Modification Document – Proposed On-Site Fuel Storage

Northland Power Belleville North L.P.

July 16, 2018

Site Plan

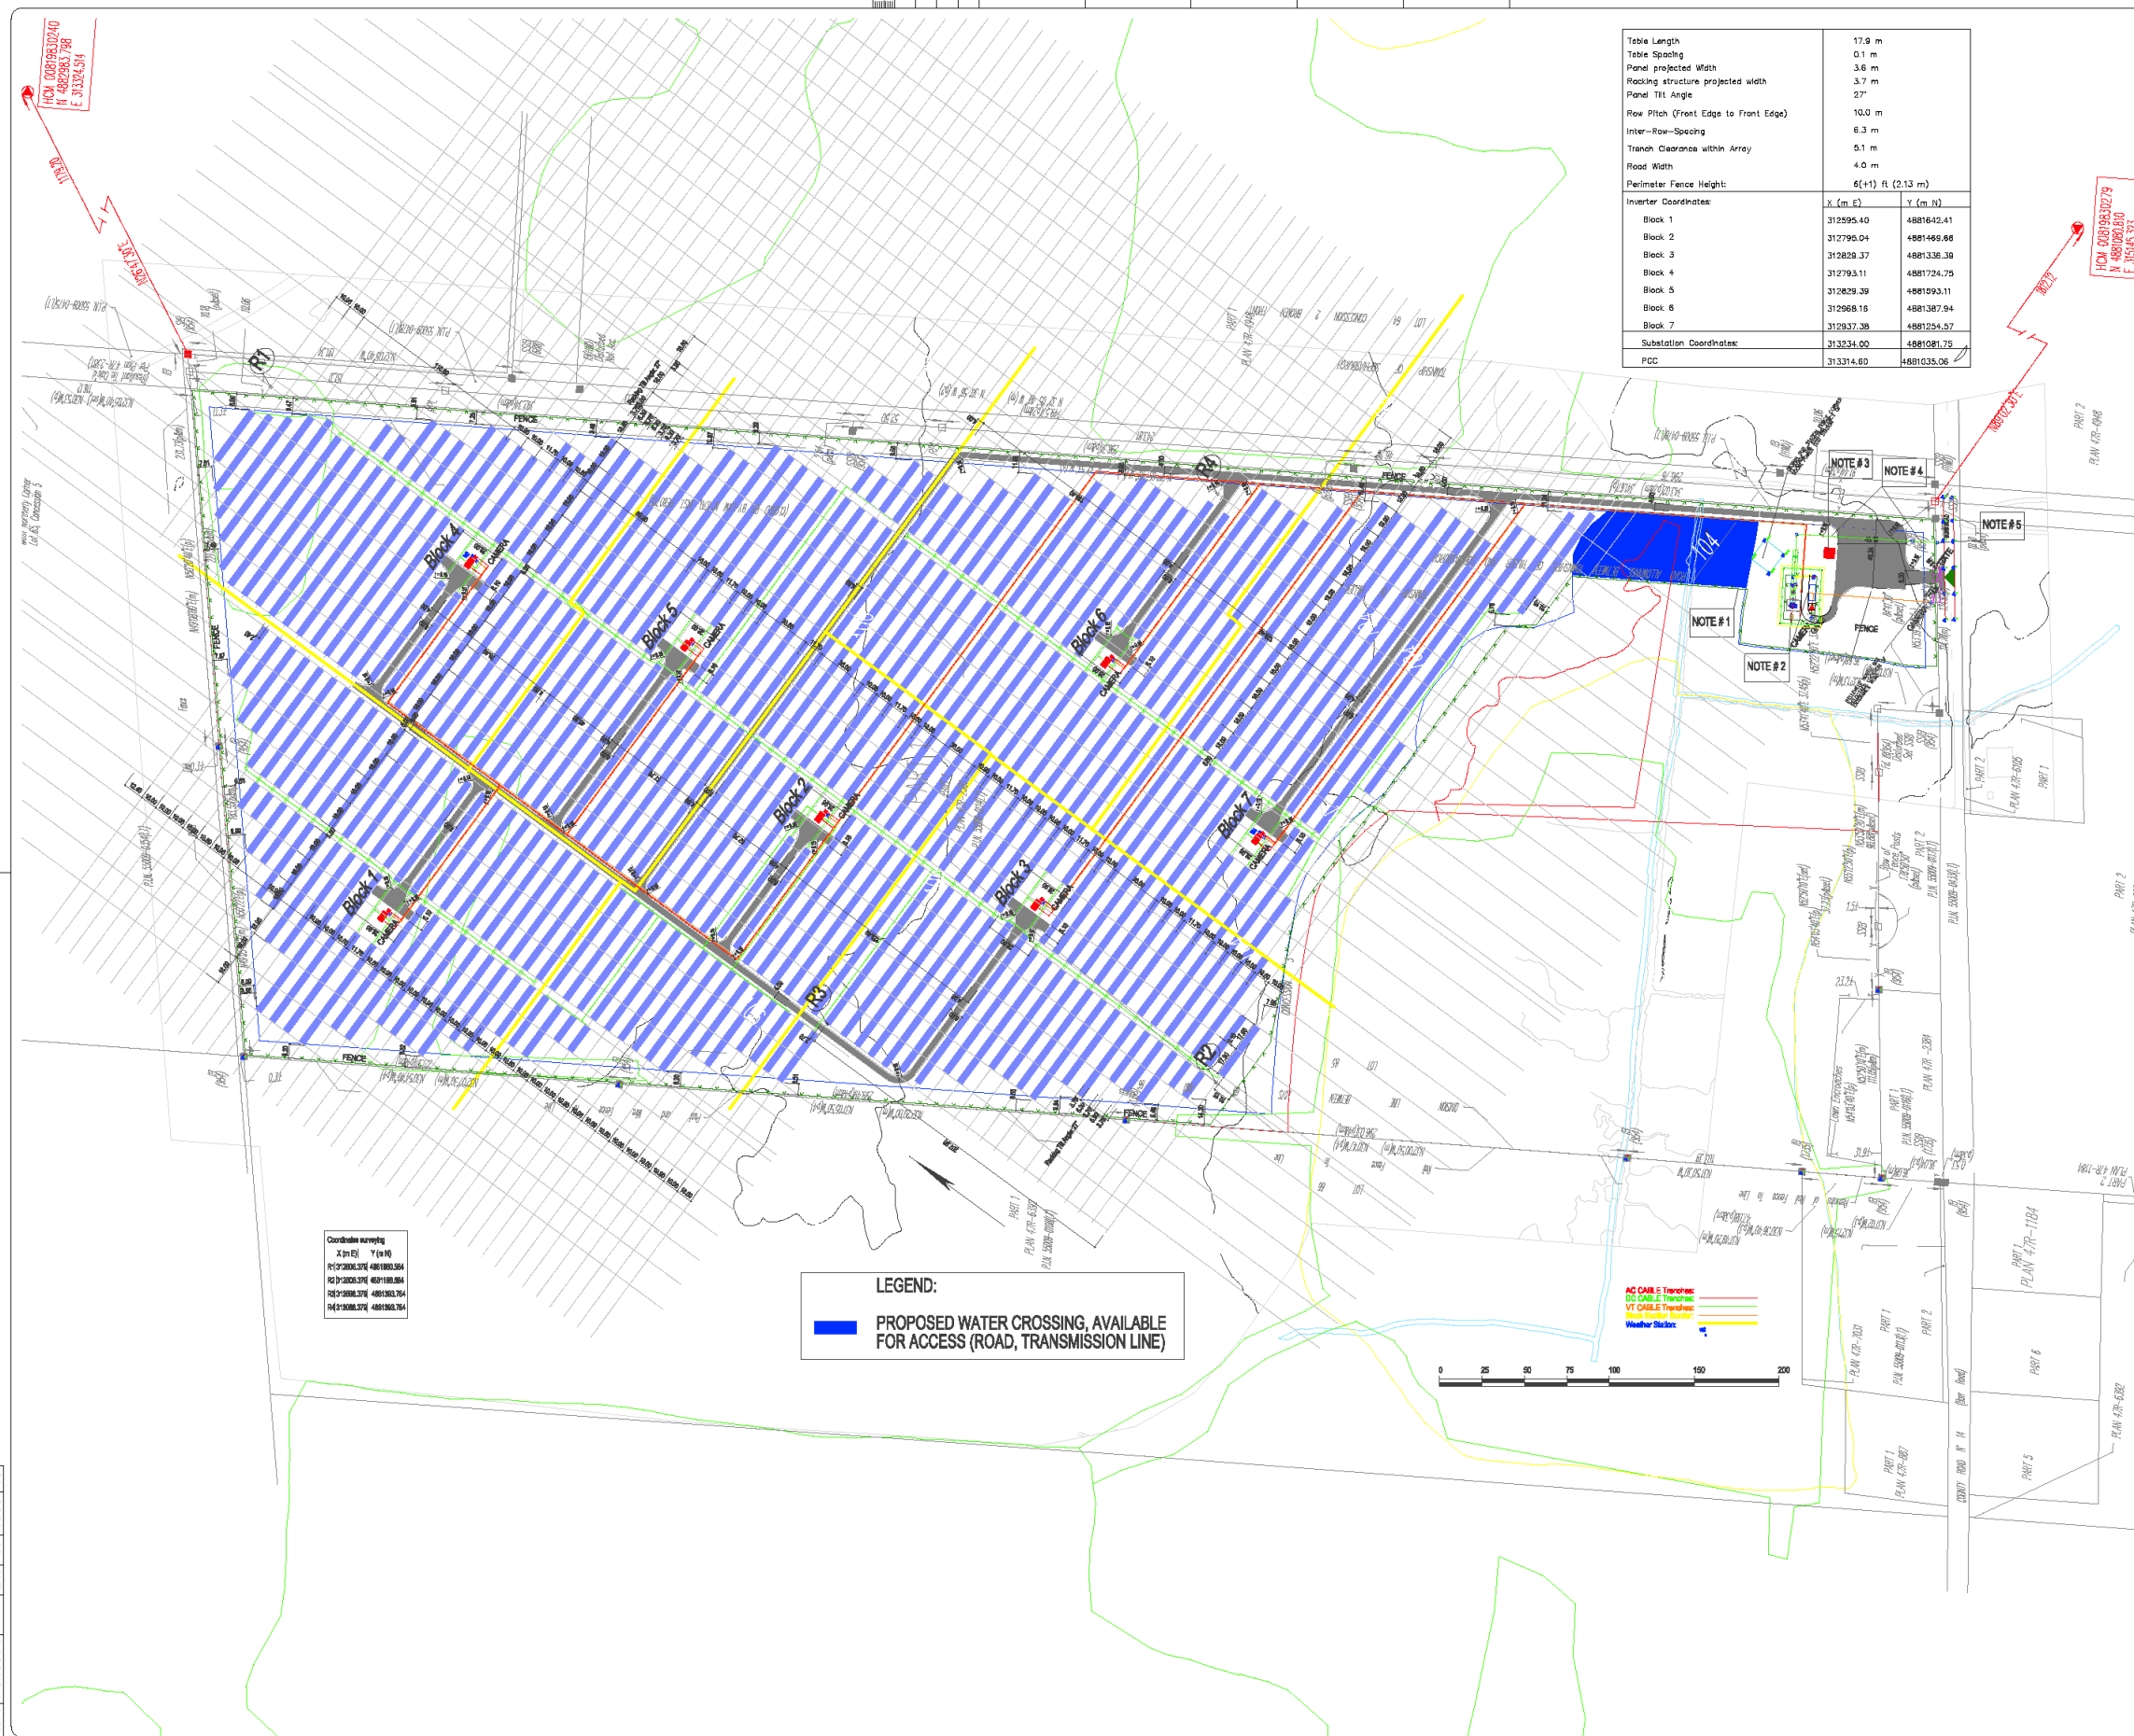
Appendix A contains a site plan drawing indicating the installation location of the proposed fuel tank.

Installation of a small fuel storage tank at the Project site.
